Access Compliance Report

Public Rights-of-Way

Intersection ID: 8643	Main Street: FAIR_ST	Cross Street: S_HOSKINS_RD	Location: W
ADA ID: 7A770184F721	Ramp Type: Perp	Initial Pass/Fail: Fail	Overall Compliance: No
		Severity Score: 10

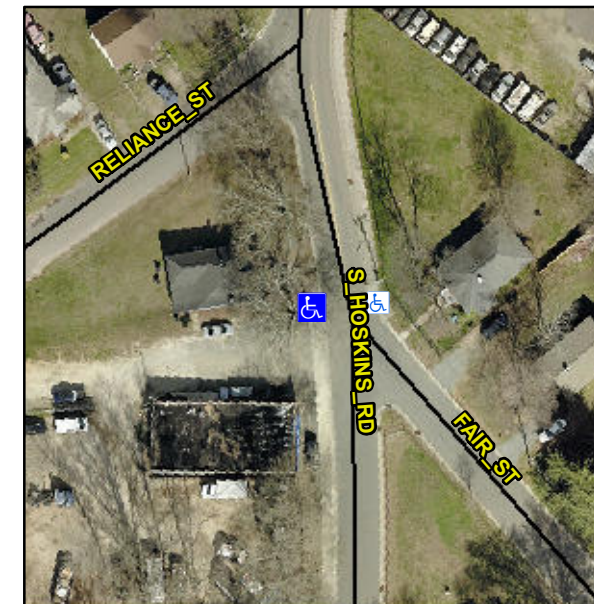
Not Found, R304.5.1, R304.5.3

Compliance	Description	Data	Compliance	Description	Data
N/A	Ramp Length (in)	72.0	Yes	Ramp Slope (%)	6.4
No	Ramp Width (in)	47.5	No	Ramp XSlope (%)	4.3
N/A	Flare Type LT	N/A	N/A	Flare Type RT	N/A
N/A	Flare Slope LT (%)	N/A	N/A	Flare Slope RT (%)	N/A
N/A	Flare Traversable LT?	N/A	N/A	Flare Traversable RT?	N/A
N/A	Landing Length (in)	N/A	N/A	DWS Provided?	N/A
N/A	Landing Width (in)	N/A	N/A	DWS Contrast?	N/A
N/A	Landing Slope (%)	N/A	N/A	DWS Length (in)	N/A
N/A	Landing X Slope (%)	N/A	N/A	DWS Full Width?	N/A
N/A	Landing Curb? (Y/N)	N/A	N/A	DWS Offset (in)	N/A
N/A	Shared Landing?	N/A			
N/A	Gutter Ponding?	N/A	N/A	Gutter Slope (%)	N/A
N/A	Gutter Lip Ht (in)	N/A	N/A	Gutter X Slope (%)	N/A
N/A	Painted X Walk1?	No	N/A	Painted X Walk2?	N/A
	X Walk 1 Direction	To E		X Walk 2 Direction	N/A
N/A	X Walk 1 Width (in)	N/A	N/A	X Walk 2 Width (in)	N/A
	X Walk 1 Slope (%)	3.8		X Walk 2 Slope (%)	N/A
	X Walk 1 X Slope (%)	5.2		X Walk 2 X Slope (%)	N/A

Remove & Replace Entire Ramp.
